SCHOMP HYUNDAI SITE PLAN MINOR AMENDMENT

AMENDMENT 1
 EXTERIOR BUILDING CANOPY,
 UTILITY AND PARKING
 IMPROVEMENTS

REVISION DESCRIPTION	DATE	#	DRN	CHK	DSG	SCHOMP HYUNDAI SITE PLAN MINOR AMENDMENT 100 NORTH HAVANA STREET, AURORA, COLORADO 80010	COVER SHEET
SUBMITTED TO AURORA	3/9/22	1	TWD	TWD			
JOB NO.	SCALE	DATE	SHEETS	SHEET	ACTION CIVIL ENGINEERING 9777 PYRAMID CT, SUITE 150 ENGLEWOOD, CO 80112 720.826.3965 tdenning@actioncivileng.com		
2203	---	6/23/2022	7	1

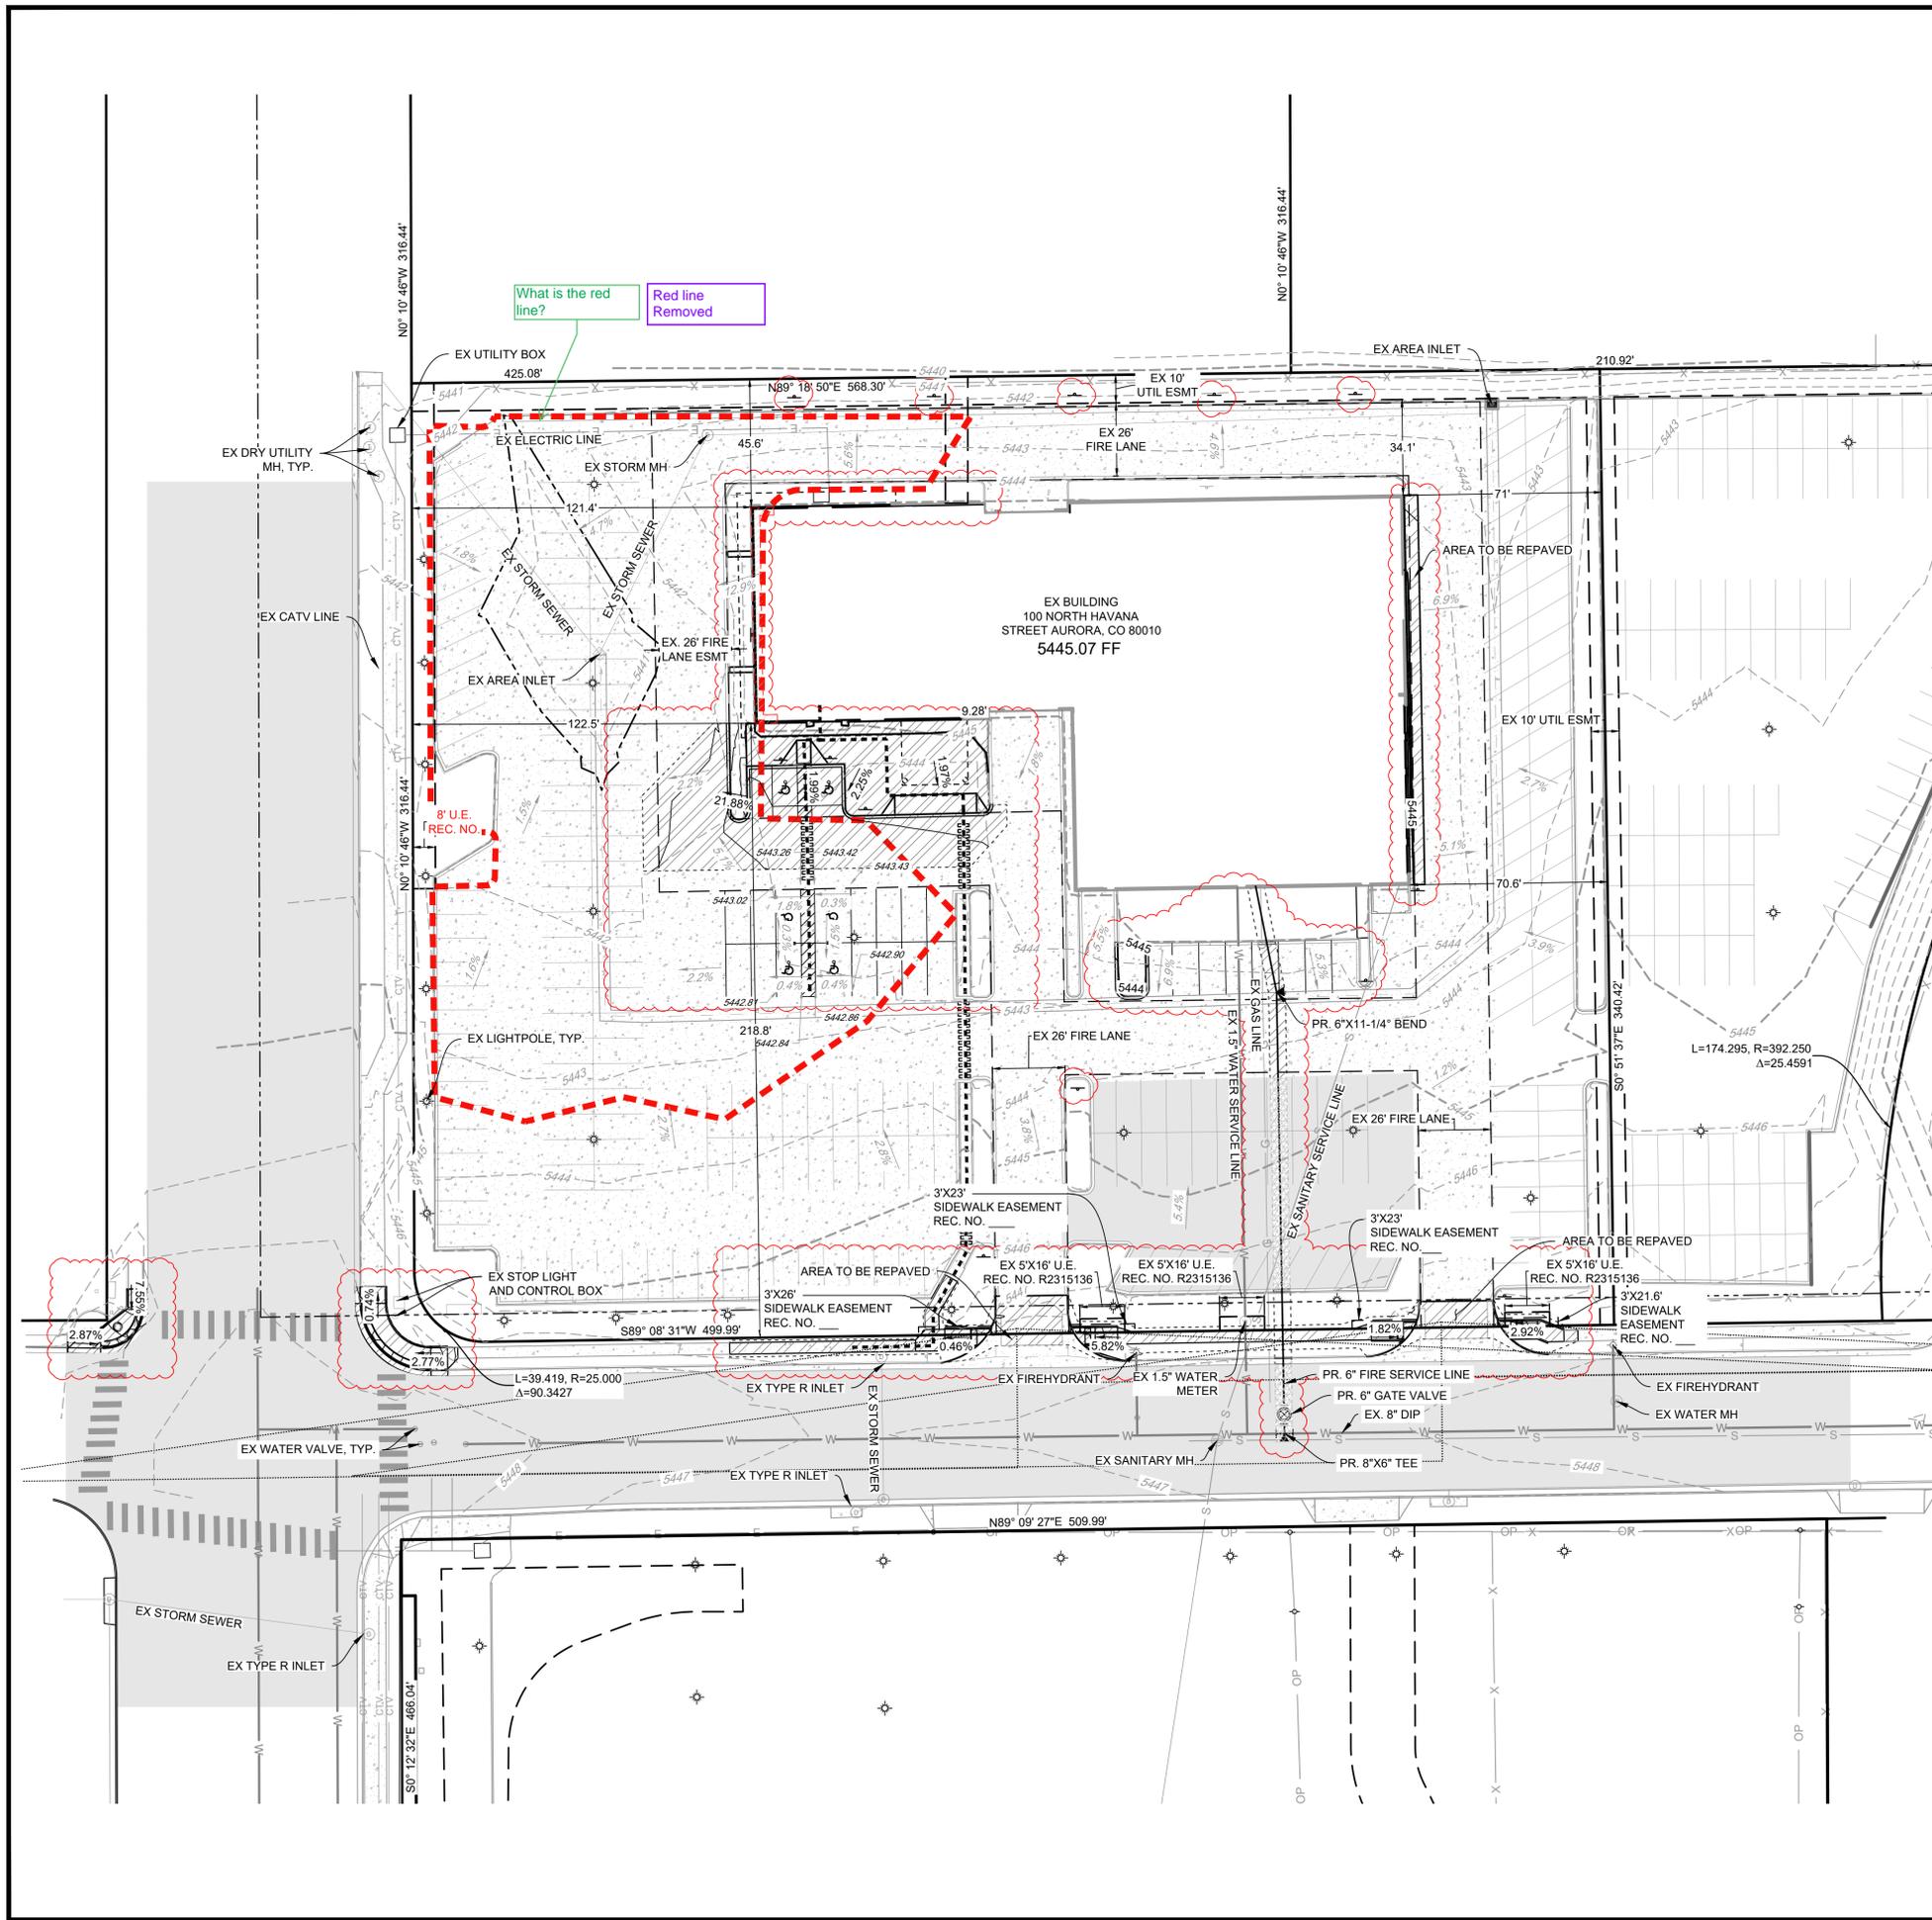
Add a note indicating if the storm sewer system is public or private and who will maintain it.
 Acknowledged

SCHOMP HYUNDA SITE PLAN MINOR AMEINTMENT
 100 NORTH HAVANA STREET, AURORA, COLORADO 80010
 PARKING PLAN

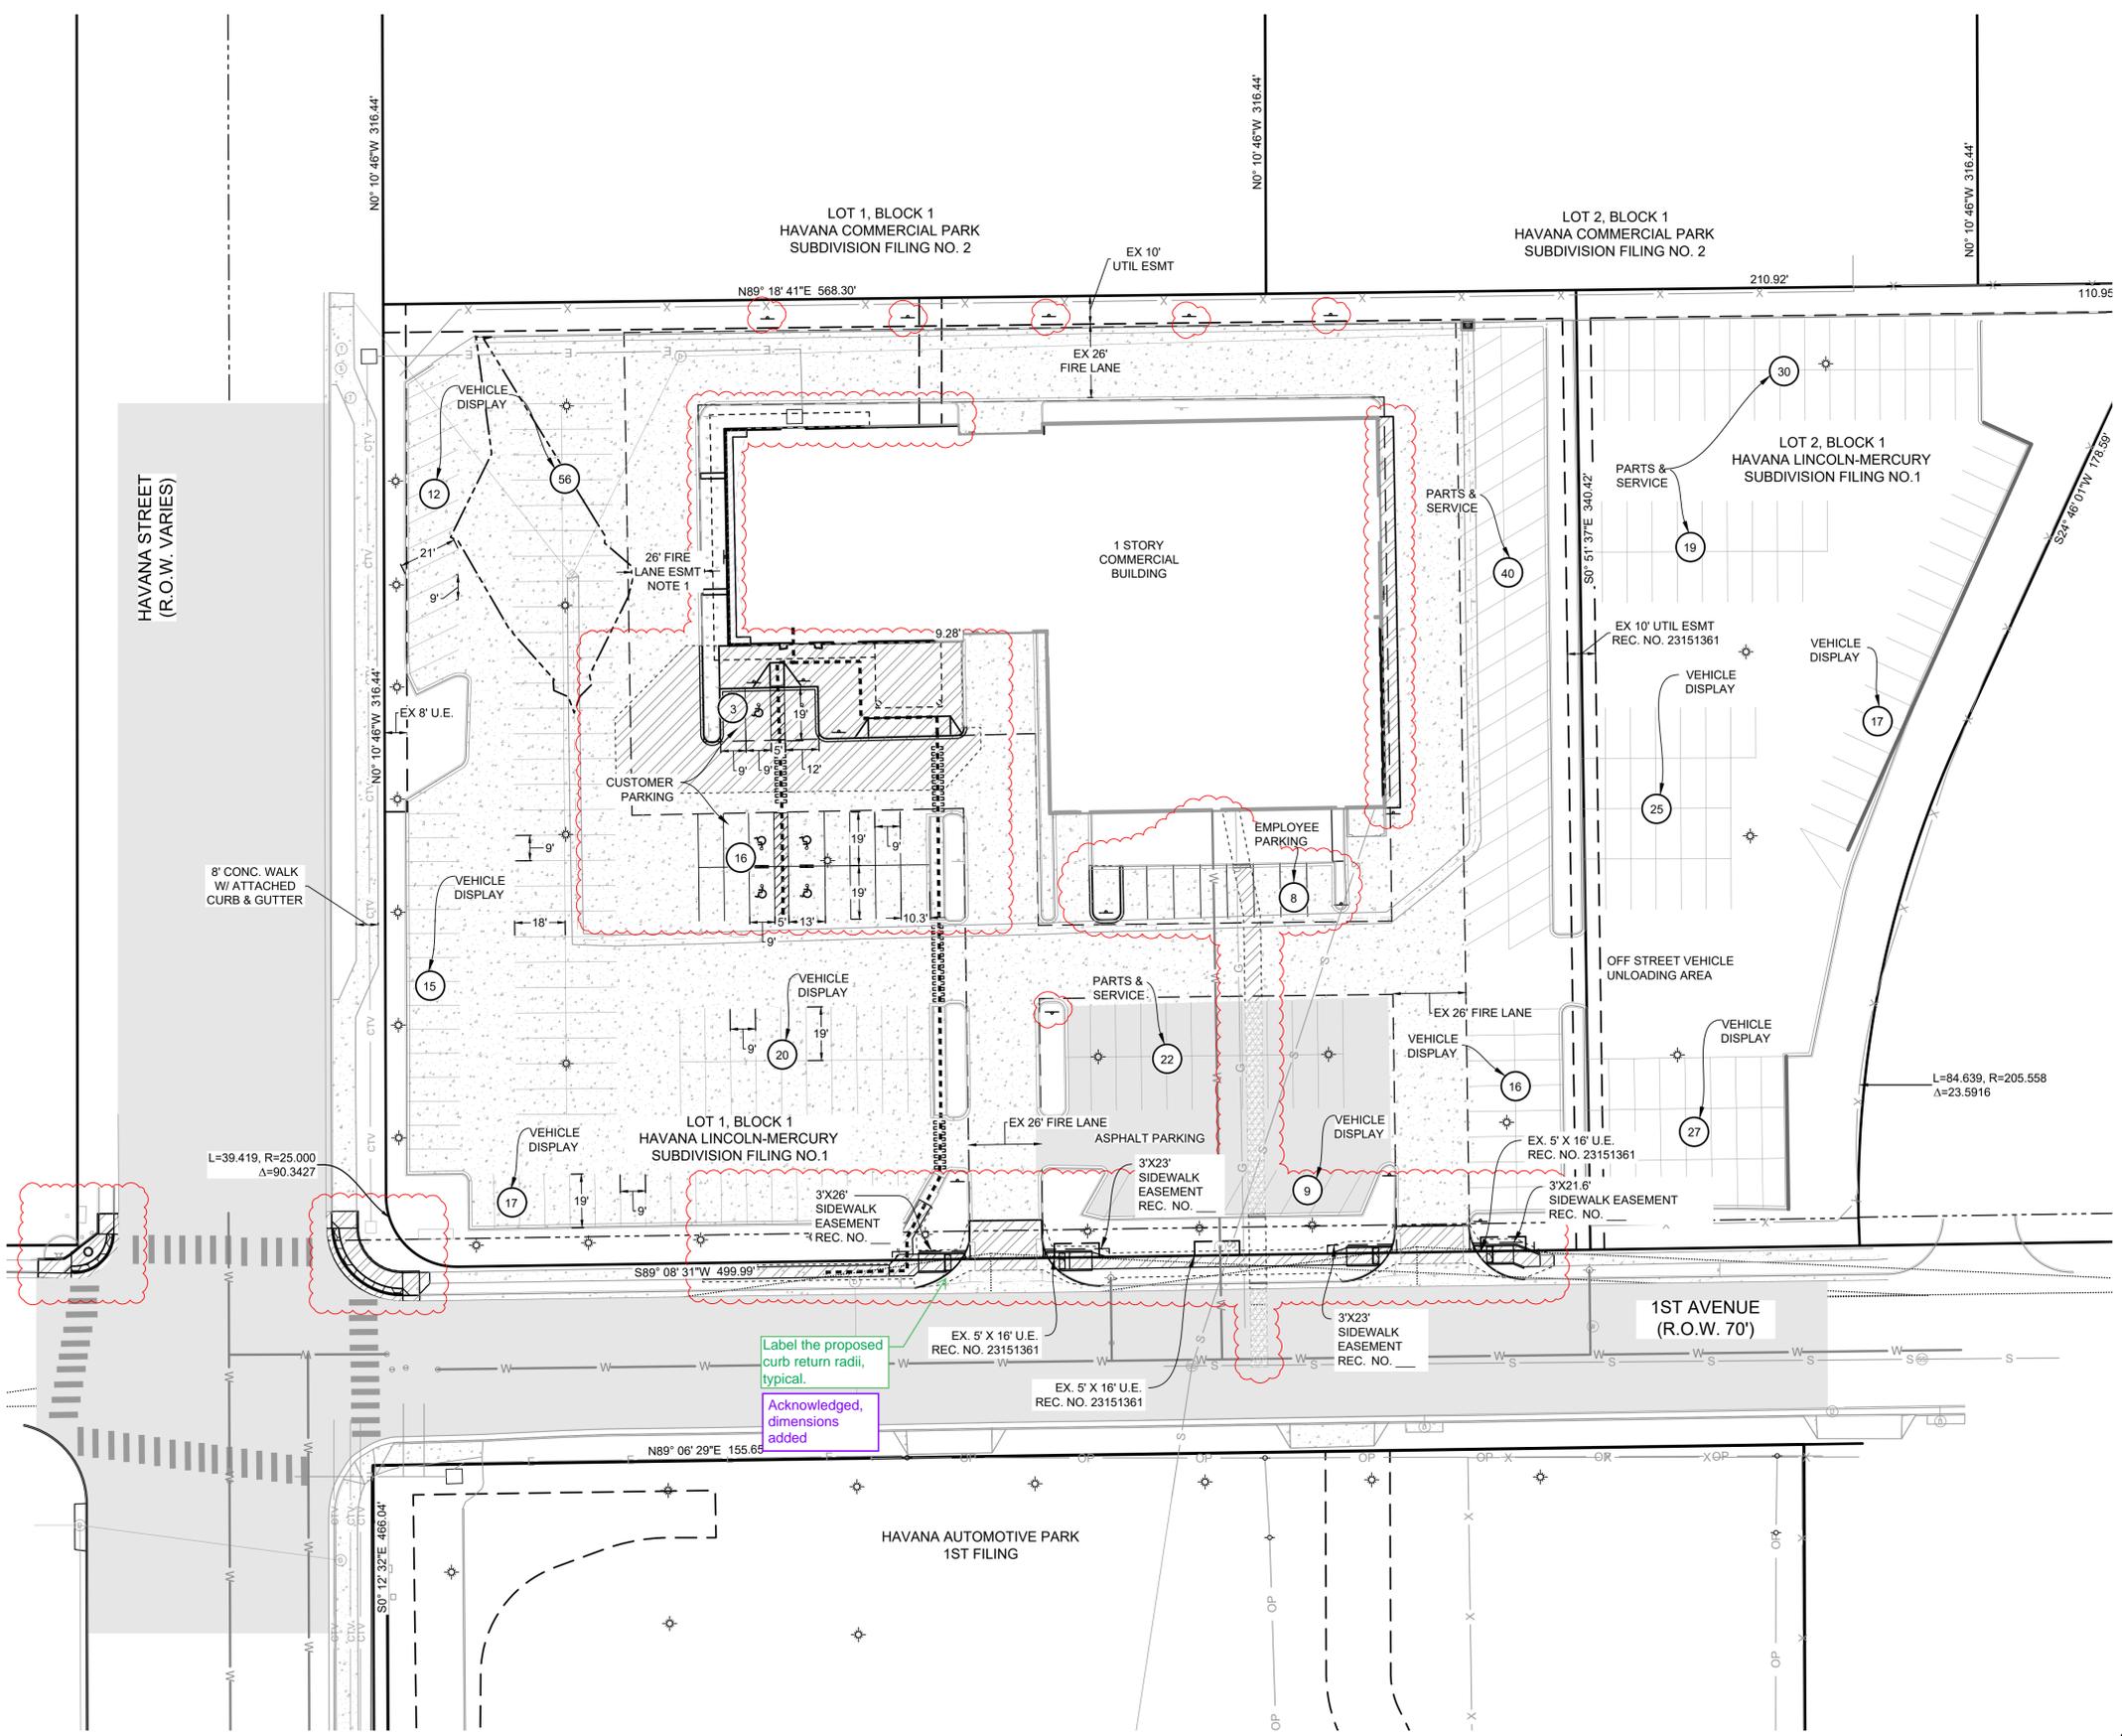
Label the proposed curb return radii, typical.
 Acknowledged, dimensions added
